Rezoning Transportation Analysis
Petition Number: Insert Zoning Petition #2021-046
General Location Identifier: 08705203

Revision Log:

Date	Description
04-29-2021	First Review (EL&KP)
05-27-2021	Second Review (EL)
06-30-2021	Third Review (KP)

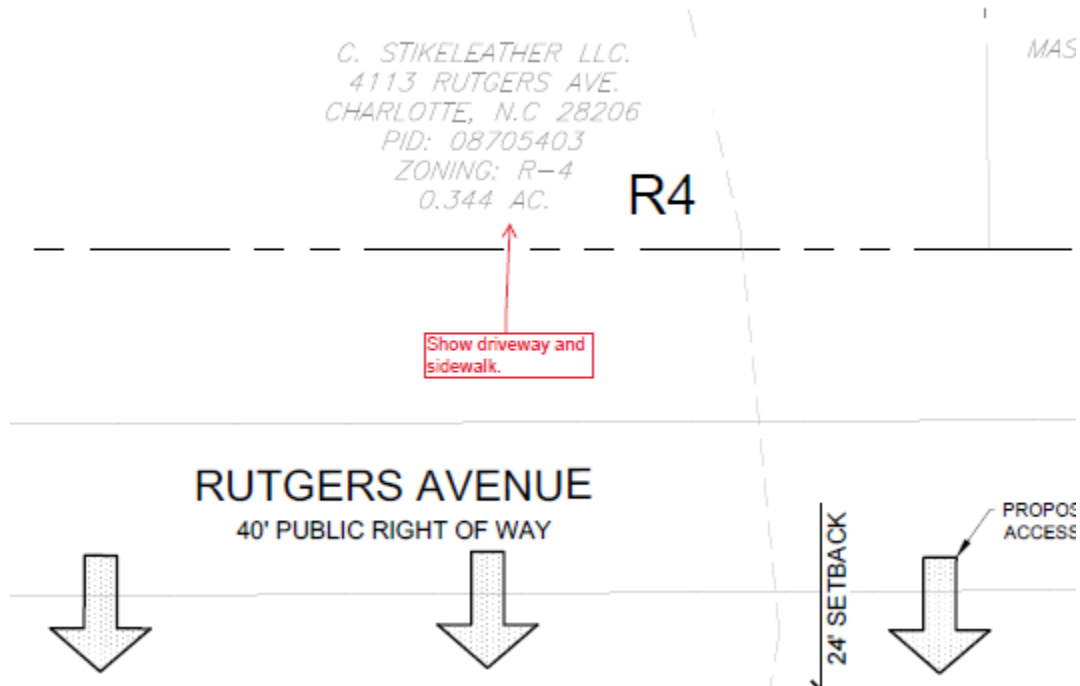
3. ~~Revise site plan and conditional notes to commit to dedicate 28 feet of right-of-way from the Rutgers Avenue centerline. The site plan shall label and dimension the right-of-way from the road centerline.~~
